Title: Cousins - Madison

RE: UDC approval **Response from 2/15/23 UDC comments:**
Cousins Subs Remodel – Madison
3715 E Washington Ave
Madison, WI
PATERA, Project Number **22-520**

This submittal is in response to comments made at the previous UDC meeting held on 2/15/2023.

Figure 1: Light Cove Detail

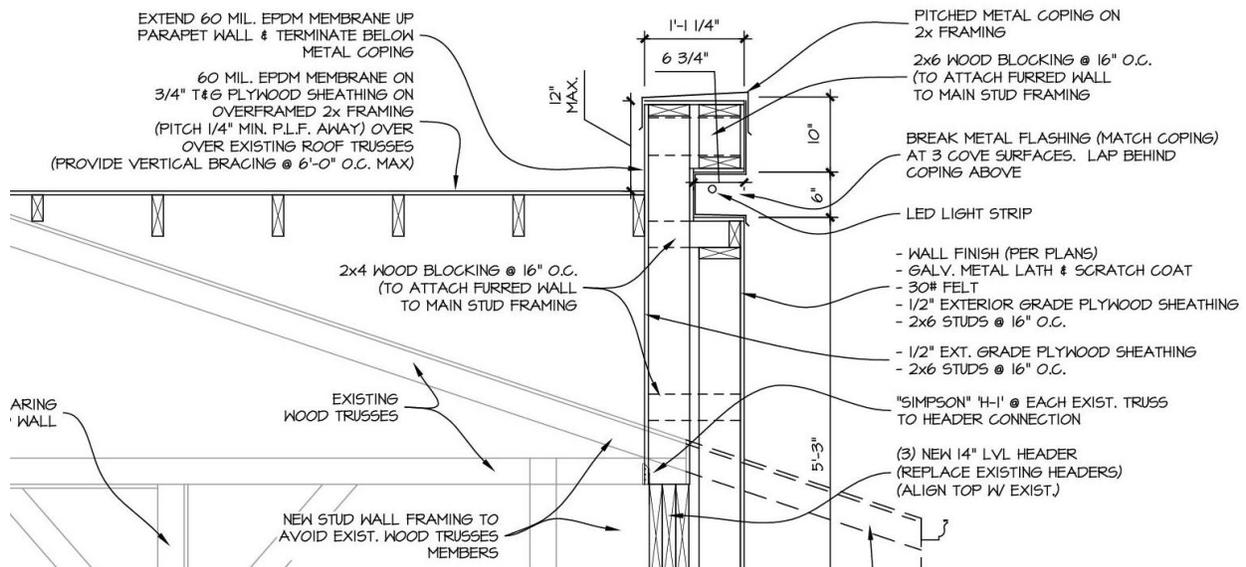
#3: The committee questioned the LED light cove and the amount of light it would produce. Included with this submittal are the cut sheets for all new outdoor light fixtures. The intent of the LED light cove is to produce a warm glow accent light. The new rendering submitted is set in a dusk scene to better show the building outdoor lighting. The updated Civil drawings also has a parking lot photometric plan. All existing light poles will be replaced with full cut off LED fixtures. No new light poles are proposed. Figure 1 shows the construction detail for the building LED light cove.

Figure 3: Dusk Scene with conceptual lighting and building façade / site updates, view of North & West walls.

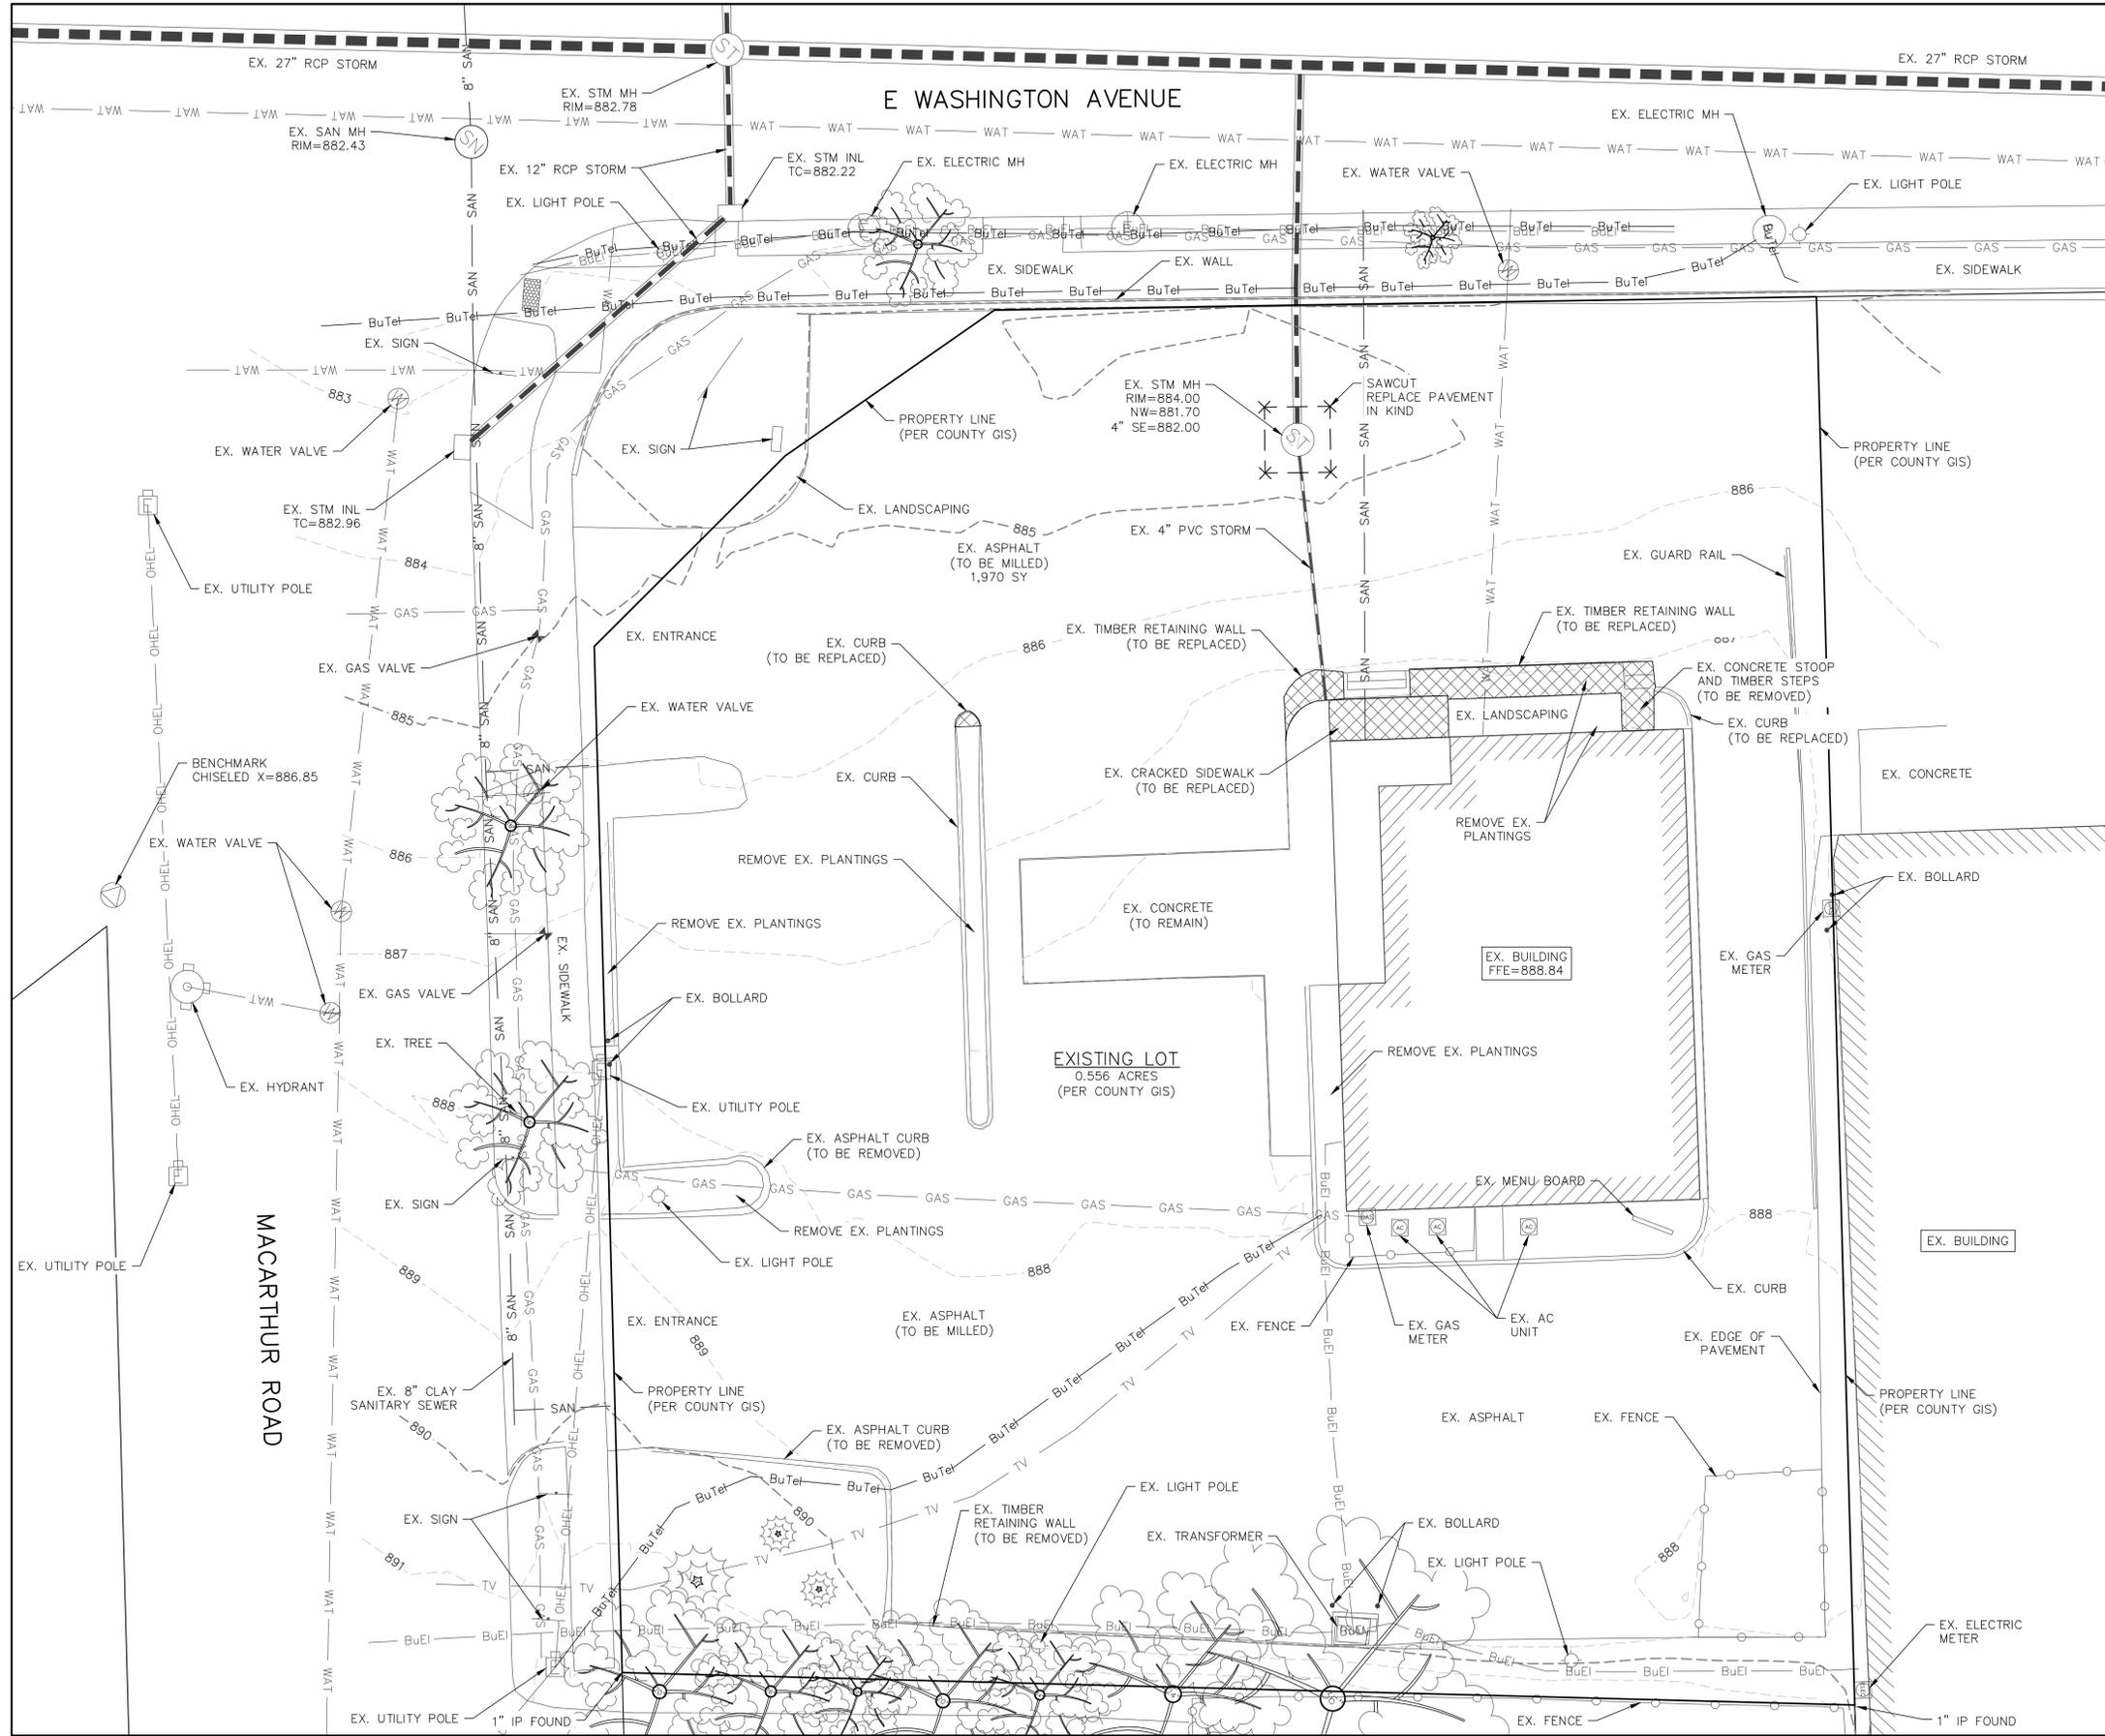
#2: The committee questioned how much of the existing roof would be visible behind the new "wood feature" parapet wall. A second rendering has been submitted showing the other side of the building, in a dusk scene. The roof will be visible and will also have new dimensional asphalt shingles installed. In addition, we have also submitted actual photographs from other completed buildings, of the same prototype building. These were taken at eye level and will be very close representations to this Washington Ave. location. See photos #1 - #3.
